# PROPOSED SECONDARY TREATMENT PLANT PICTON, BUNBURY

Ravensthorpe Mining and Investment Company Ltd

## Report and Recommendations of the Environmental Protection Authority

Bulletin No 367 November 1988

**RAVENSTHORPE MINING AND INVESTMENT CO LTD  
WATER BALANCE  
DRY TREATMENT PLANT**

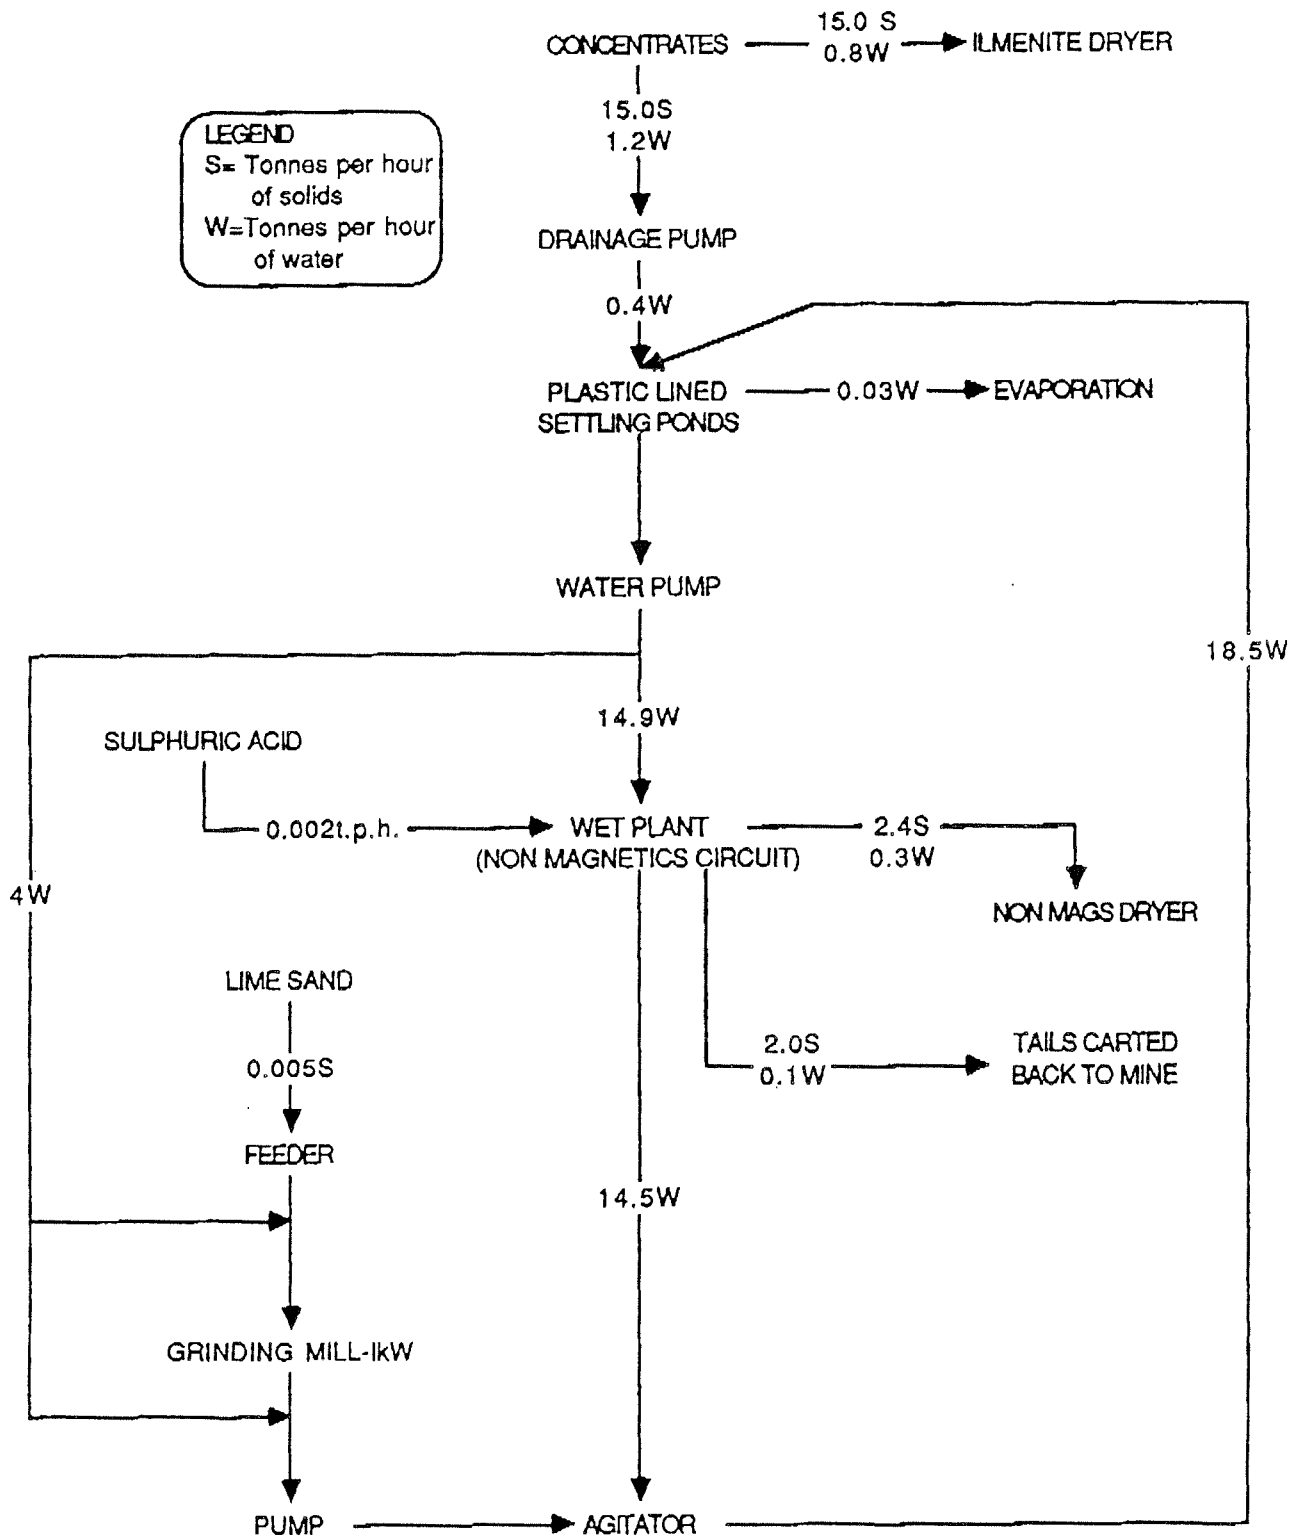
Waste water management requires more details:

- (i) Water balance.
- (ii) Is there any discharge to Ferguson River etc?
- (iii) Stormwater retention and disposal.
- (iv) There should be an oil and grease trap on any storm water outlet.
- (v) Details of possible pollution in waste water.
- (vi) Are there settling ponds?
- (vii) Settling ponds should be lined.

- (i) See attached water balance diagram.
- (ii) No.
- (iii) The design meets the engineering requirements stipulated by the City of Bunbury.
- (iv) Oil and grease traps are included in the design.
- (v) See answer to Question 1.
- (vi) Yes.
- (vii) They are lined.
